POLICY REPORT
DEVELOPMENT AND BUILDING

Report Date: April 17, 2014
Contact: Kent Munro
Contact No.: 604.873.7135
RTS No.: 10602
VanRIMS No.: 08-2000-20
Meeting Date: June 10, 2014

TO: Vancouver City Council
FROM: General Manager of Planning and Development Services
SUBJECT: CD-1 Rezoning: 5129-5169 Cambie Street

Elevations

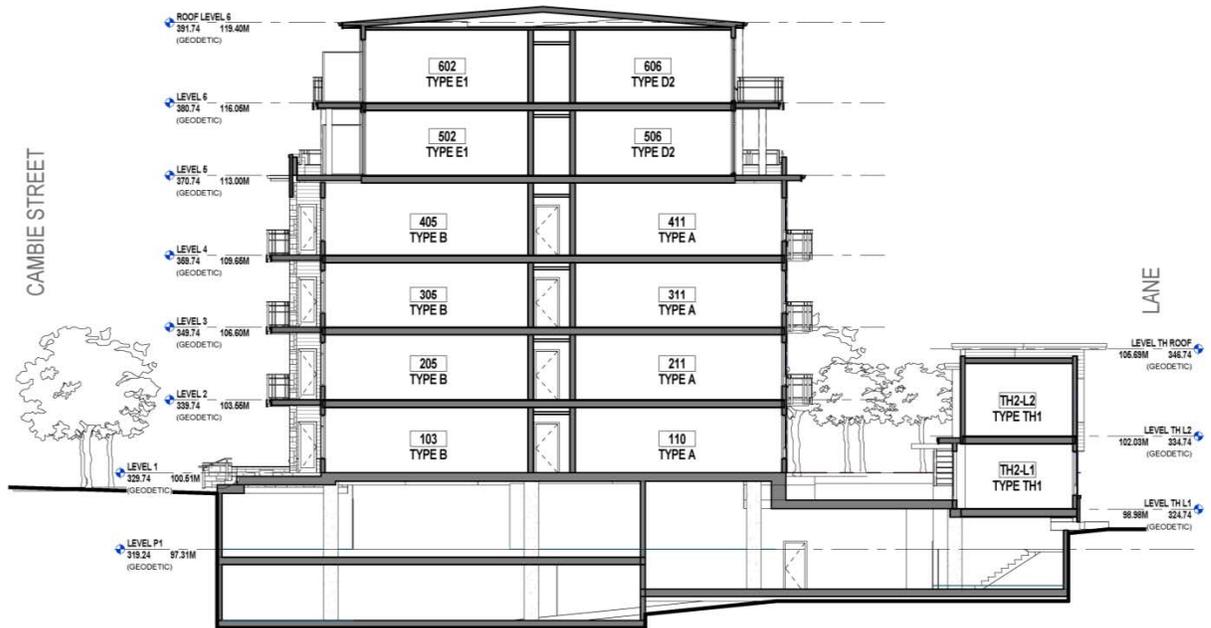
- 3. Design development to reduce the perceived length of the duplexed townhouses along the lane.
- 4. Design development to improve the juxtaposition of materials and colour. A design strategy implementing a simplified complementary colour palette would assist in presenting a more cohesive building form.

- **Panel's Consensus on Key Aspects Needing Improvement:**
 - Design development to improve the perceived length of the building;
 - Design development to improve entrance;
 - Design development to improve the material change;
 - Design development to improve the northeast corner;
 - Design development to improve the density in the townhouses;
 - Consider improving the colour palette.

The Panel supported the height, massing, density and form of development. Most of the Panel supported the 150 foot length of the building but felt there was an abrupt material change that needed to be improved. As well a number of Panel members thought the expression didn't do anything to break up the monotony of expression and perceived length of the building. They thought the entrance was lost in the elevation and that the massing could transition better on the lane to the single family homes.
